**TOWN OF YARMOUTH**  
200 Main Street, Yarmouth, Maine 04096  
[www.yarmouth.me.us](http://www.yarmouth.me.us)

To: Chair Holden and Members of the Yarmouth Planning Board  
From: Erin Zwirko, Director of Planning & Development  
Re: Railroad Square Master Plan – Development Plan and Major Subdivision Meeting 3  
Date: March 3, 2022

The applicant submitted an updated Lot, Use and Thoroughfare Plan:

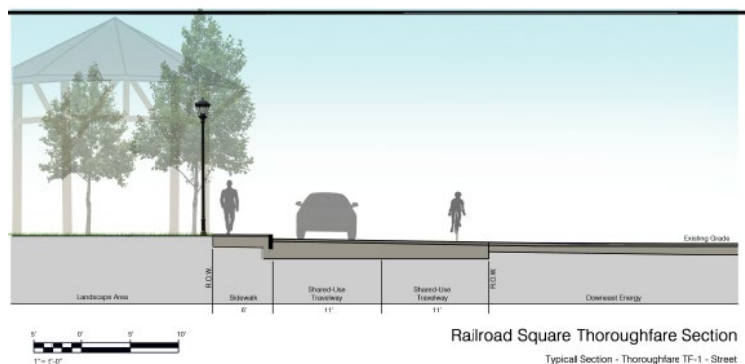
For this submittal, the applicant revised the circulation through the parking lot on Lot 3 to be one-way circulation consistent with comments made at the January 12<sup>th</sup> meeting. All other aspects remain the same, including the need for a waiver for the pre-existing condition existing at Lot 1.

In addition, sections of each Thoroughfare proposed were submitted for discussion. As documented, the applicant is utilizing *Road*, *Village Street*, *Shared Space Street* and *Bike-way/Multi-Use Path*. Below are the sections provided with the design requirements from the CBDC.

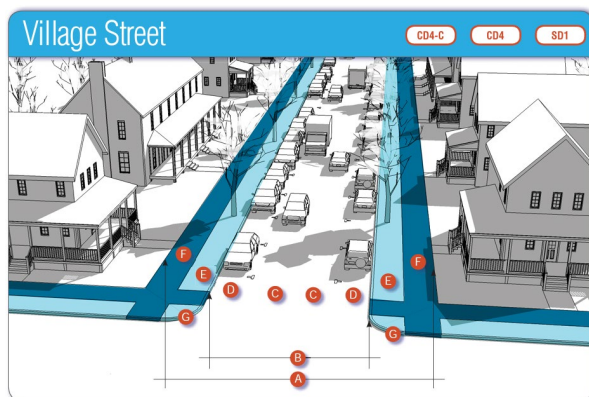
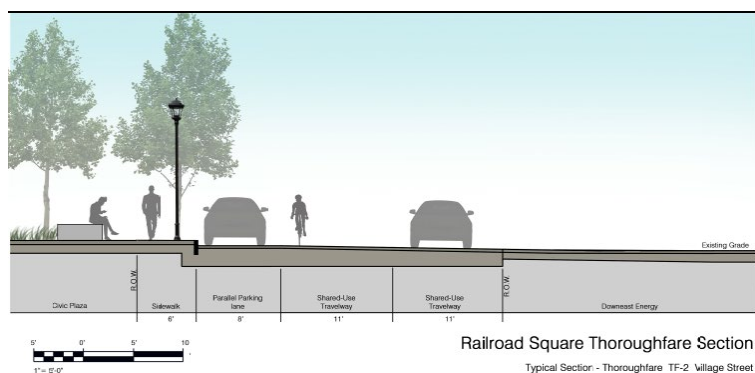
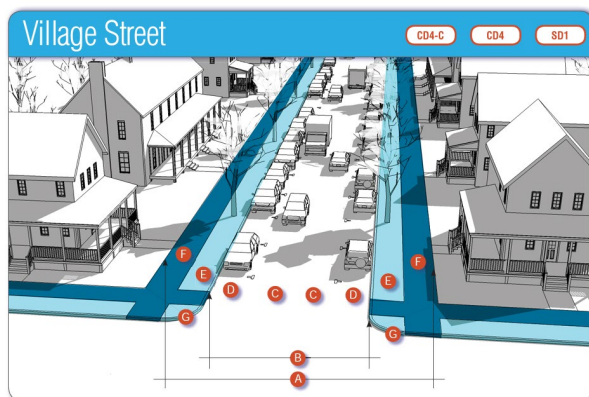
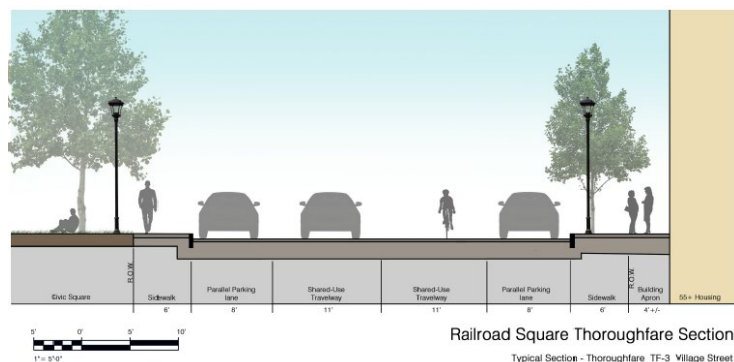
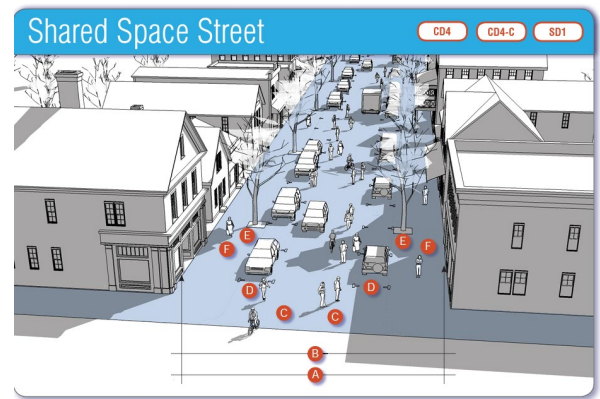
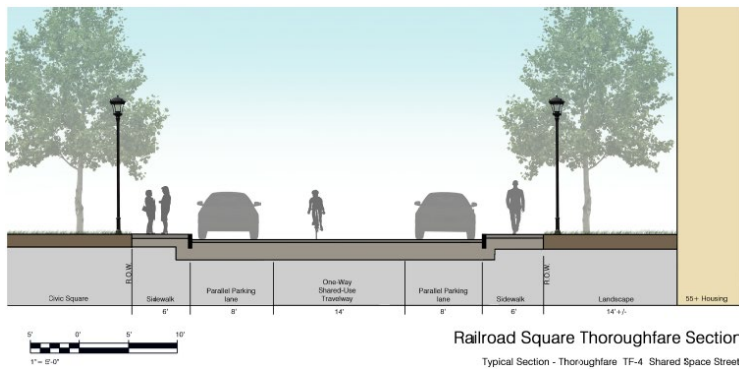
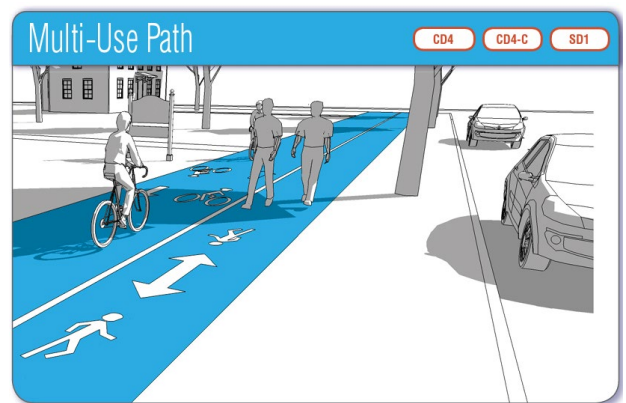
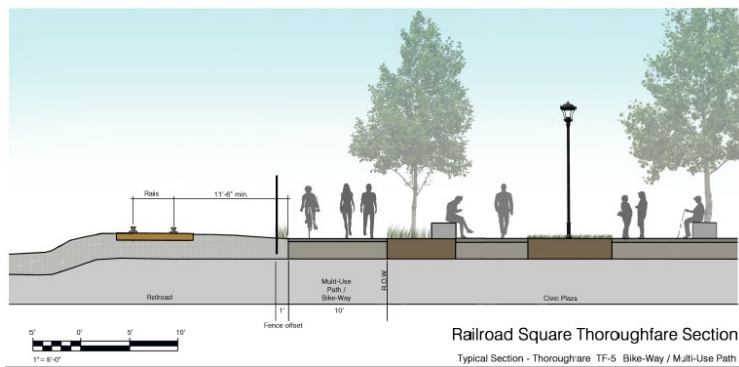
Article 6.E.2 and Article 6.E.3 are the various standards for Thoroughfares and Public Frontages. Within these standards are qualitative standards as well as threshold standards regarding the layout of the Thoroughfares. The applicant will need to respond to these details in order to document compliance, and the Planning Board will want to review the sections provided to confirm whether it is compliant with the requirements of the CBDC

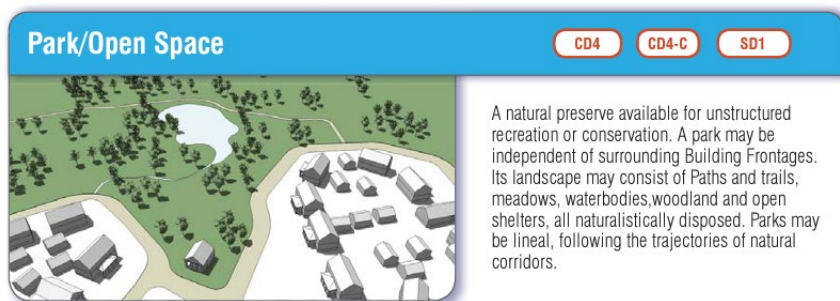
The applicant submitted a plan that documents the landscaping, buffer, and open space. The applicant writes that the plan is for illustrative purposes and that detailed plans will be provided through the permitting process for compliance. The Planning Board will need to determine whether that is sufficient for reviewing the Development Plan.

The applicant has previously indicated that they are incorporating Civic Squares, Civic Plazas, and Open Space as defined by the CBDC (see Table 6.G):

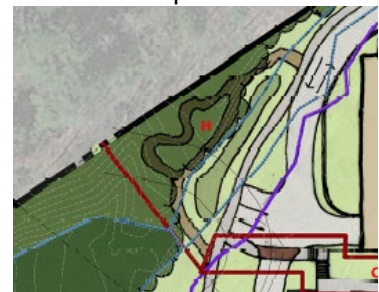
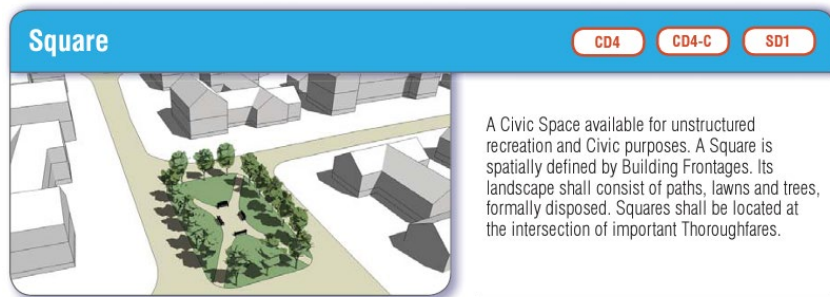
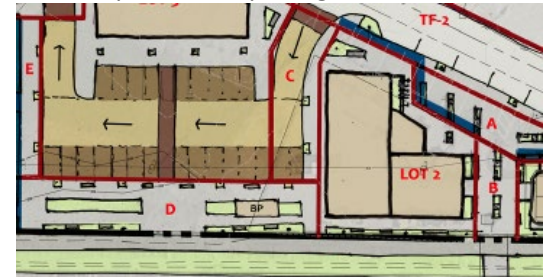
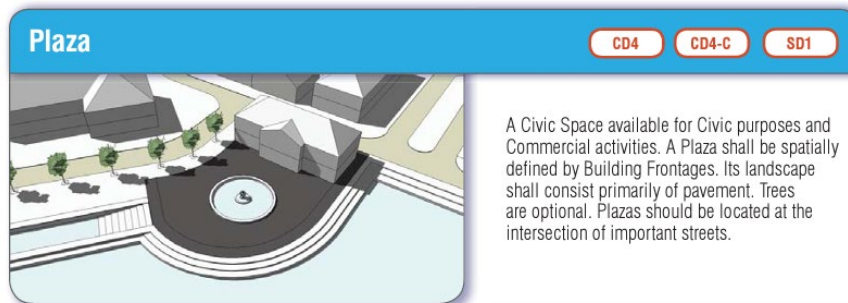
The Park/Open Space area is designated as H on the Development Plan, and the applicant has indicated that it will feature a trail connection for passive recreation:

The Civic Square is designated as F on the Development Plan, a public green and square with canopy trees:

Two Civic Plazas are proposed, designated as A and D on the Development Plan, connected to other elements of the Development Plan through sidewalks, shared spaces, and passages:

At the March 9<sup>th</sup> Planning Board meeting, the playground at Rowe School was identified as a playground that meets the second standard. Of the various civic spaces described in the CBDC, the Planning Board will want to consider whether these are appropriate selections for the development proposed, and how the civic spaces meet these standards.
